**COMMUNITY DEVELOPMENT
DEPARTMENT REPORT**

HEARING: June 18, 2026
DATE: *Continued from: 5/21/2026*
TO: Planning & Zoning Commission
FROM: Sonya Allen, Associate Planner
208-884-5533
sallen@meridiancity.org
APPLICANT: Kelli Black, Bailey Engineering
SUBJECT: Storyrock – AZ, MDA, PP, RZ
H-2025-0025

F. Annexation Legal Description & Exhibit Map – NOT APPROVED

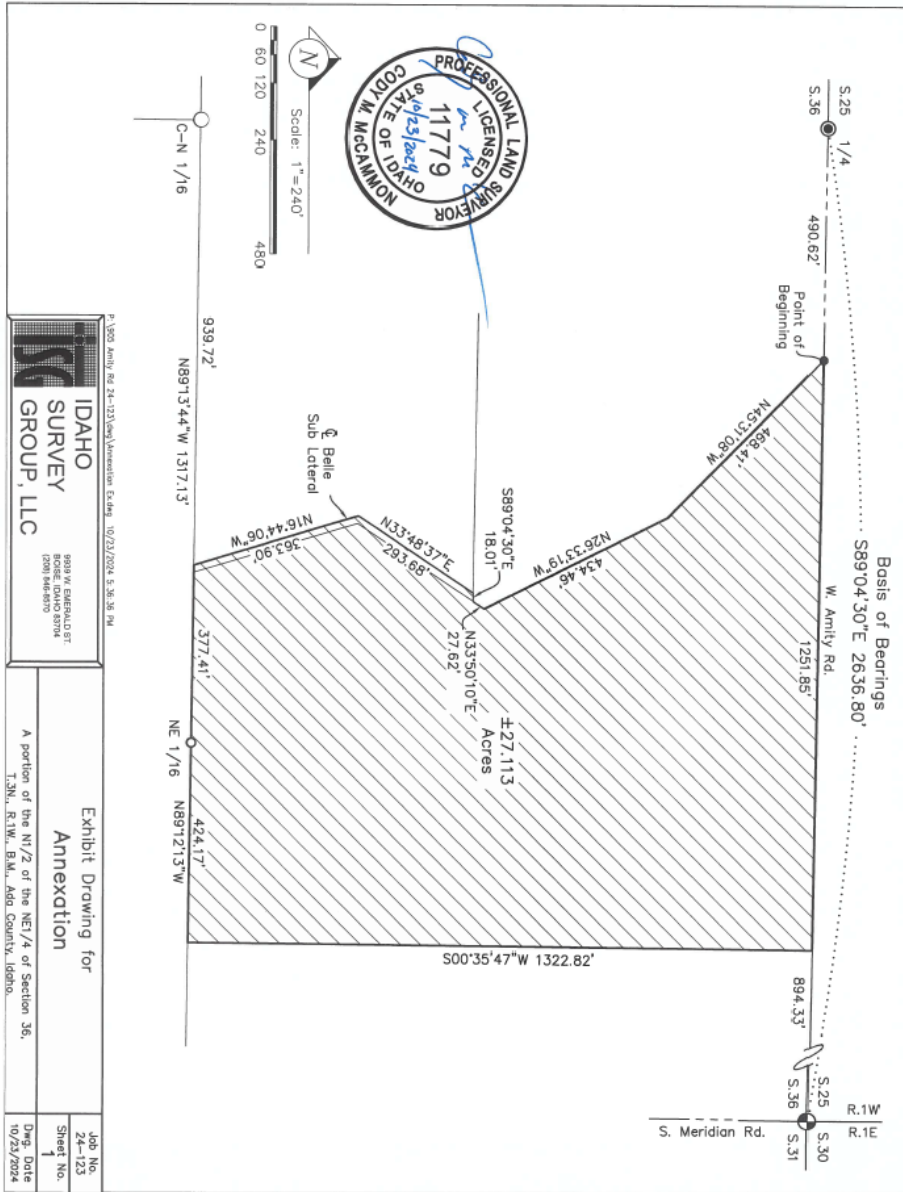
Because the property located at 455 W. Amity Rd. is designated Medium-Density Residential (MDR) on the Future Land Use Map (FLUM), Staff recommends zoning the property R-15 rather than L-O, consistent with the surrounding area and to facilitate future residential redevelopment consistent with the Comprehensive Plan. The existing use may continue as a legal nonconforming use within the R-15 zoning district, subject to the provisions of UDC 11-1B-4. Accordingly, the annexation legal descriptions and exhibit maps for the R-15 and L-O zoning districts should be revised prior to the City Council hearing. **The R-15 and L-O annexation legal descriptions and exhibit maps should be revised accordingly prior to the City Council hearing.**

- The annexation legal descriptions and exhibit maps for the R-15 and L-O zoning districts are revised to reflect R-15 instead of L-O zoning for the property at 455 W. Amity Rd.;
- The preliminary plat is revised to include irrigation easements wider than 10' in a common lot that is a minimum 20' wide and outside of a fenced area in accord with UDC 11-3A-6E.
- The preliminary plat phasing plan is revised to reflect the first phase of development on the east side of the development rather than the west to facilitate the extension of sewer and water services as well as the construction of road improvements to serve the Mills and Stonehill Church properties, the extension of S. Pullman Ave. to the southern property boundary, and street buffer and pedestrian facilities along W. Amity Rd. between the collector street (i.e. Oakbriar) and the east property line.

I. Phasing Plan (dated: 11/12/2025) – **NOT APPROVED**

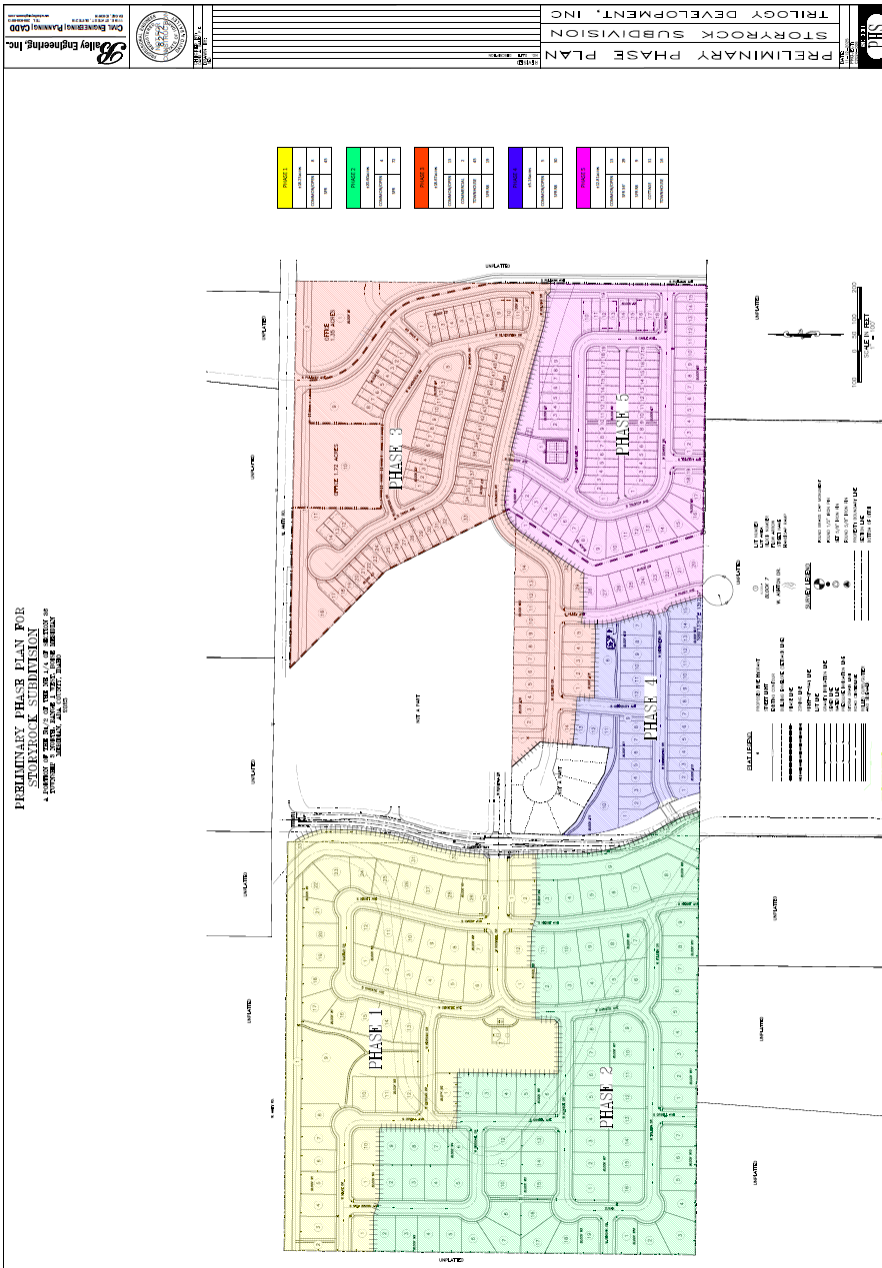
3. Because sewer service will be extended from the southeast to serve the eastern portion of the development from S. Meridian Rd. through the proposed Syringa Crossing development, Staff recommends revising the phasing plan to begin development on the east side of the site rather than the west. The extension of sewer and water services, as well as the construction of road improvements to serve the Mills and Stonehill Church properties, the extension of S. Pullman Ave. to the southern property boundary, and construction of the street buffer and pedestrian facilities along W. Amity Rd. between the collector street (i.e. Oakbriar) and the east property line, should occur with the first phase of development.

The plat is proposed to develop in five (5) final plat phases starting on the west side of the development. **Because sewer service is being extended from the southeast to serve the eastern portion of this development from S. Meridian Rd. through the proposed Syringa Crossing development, Staff recommends the phasing plan is revised to reflect the first phases of development on the east side of the development rather than the west (see Section F.4 below for more information).**

Staff recommends the street buffer along W. Amity Rd. between the collector street (i.e. Oakbriar) and the east property boundary is constructed with pedestrian facilities with the first phase of development; the phasing plan should be revised accordingly.

J. Landscape Plan (date: 8/7/2025)

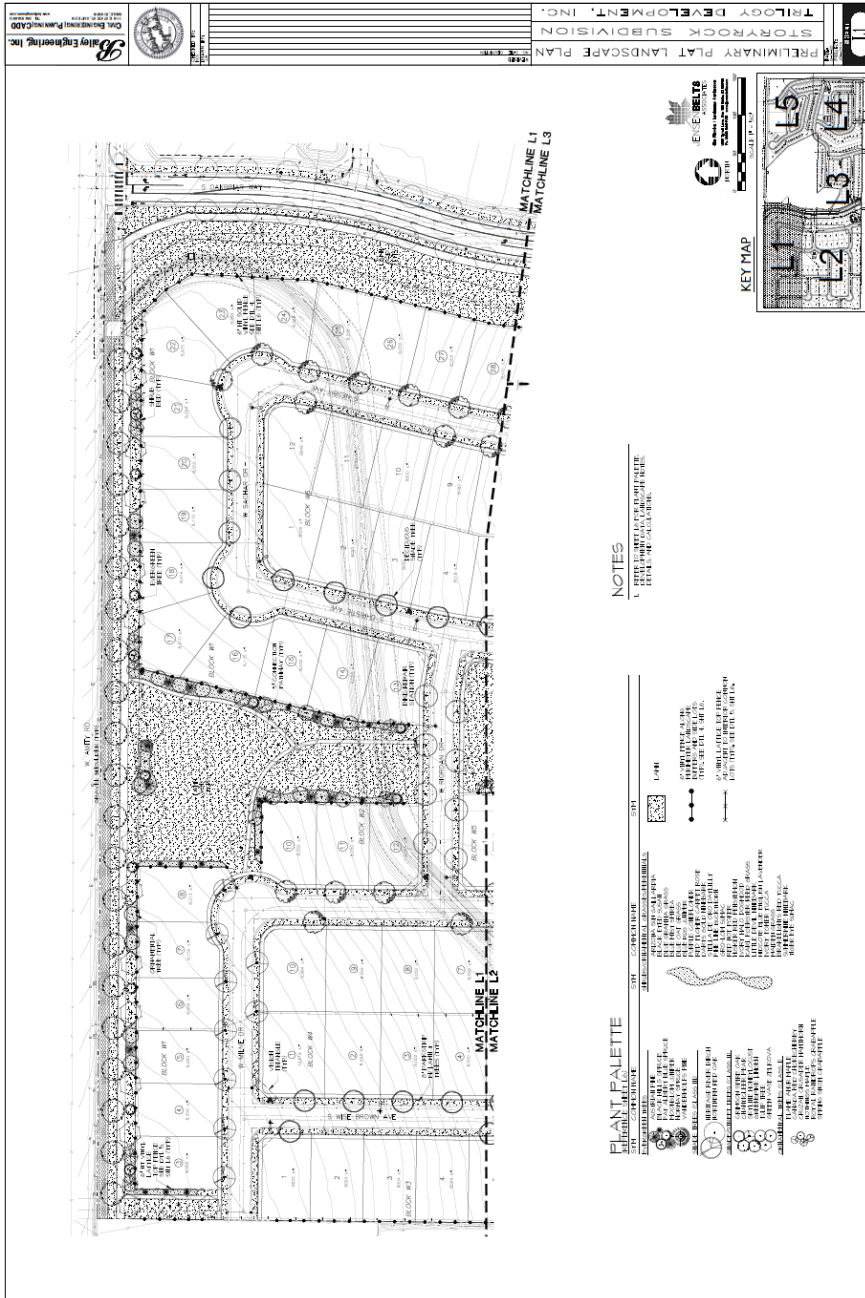
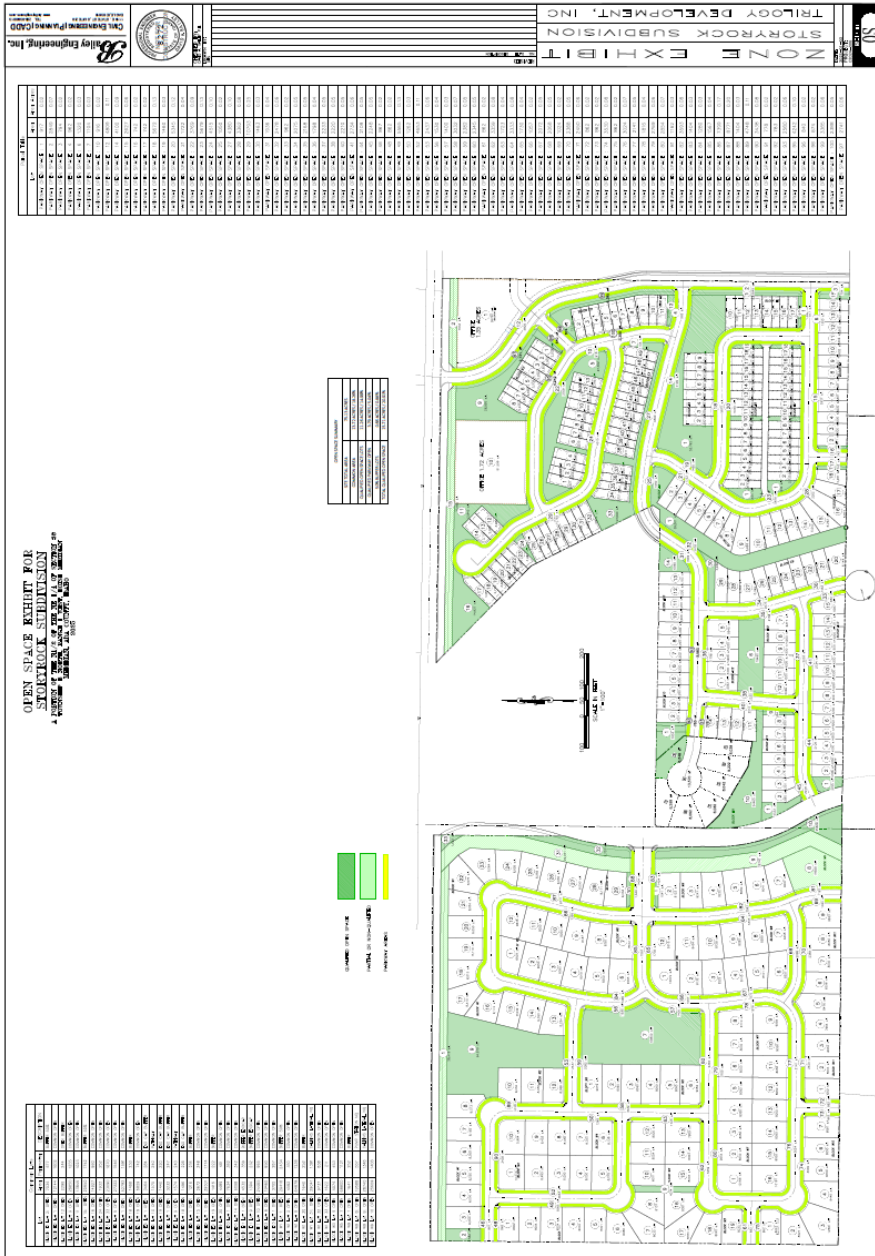
The street buffers along W. Amity Rd. (arterial) and S. Oakbriar Way (collector) are required to comply with the enhanced buffer requirements in UDC 11-3G-3B.3 and 11-3B-7C.3f in order to count toward the qualified open space requirement. Details should

be included on a revised landscape plan explaining what enhanced buffer elements are proposed.

Micro-path lots are required to be a minimum of 20' in width in order to qualify toward the qualified open space requirement for linear open space. The plat and landscape plan should be revised accordingly.

The Landscape Calculations table on the landscape plan should include the following: length and width of the street buffer and tree classifications for S. Oakbriar Way, Pullman Ave. (if designated as a collector street) and road through Lot 10, Block E3; length and width of parkways (aka residential subdivision trees) and the required vs. provided number of street trees and tree classification.

vegetative groundcover. **The square footage of common areas and the required number of trees should be included in the Landscape Calculations table on the landscape plan.**

The landscape strips are required to be planted with a mix of trees, shrubs, lawn, and/or other vegetative groundcover. A minimum of one (1) tree per 100 linear feet of pathway is required. **The length of pathways and required vs. proposed number of trees that demonstrate compliance with the standards in UDC 11-3B-12C should be included in the Landscape Calculations table.**

- iv. Depict irrigation easements wider than 10' in a common lot that is a minimum of 20' wide and outside of a fenced area, unless otherwise waived by Council per UDC 11-3A-6E. *This applies to Lots 2 & 3, Block E9 and Lots 5-9, Block E5. Revise the landscape plan accordingly.*

- v. If S. Pullman Ave. will be classified as a collector street, a 10' wide detached sidewalk/pathway should also be provided along both sides of the street on this site. *Revise the landscape plan accordingly.*
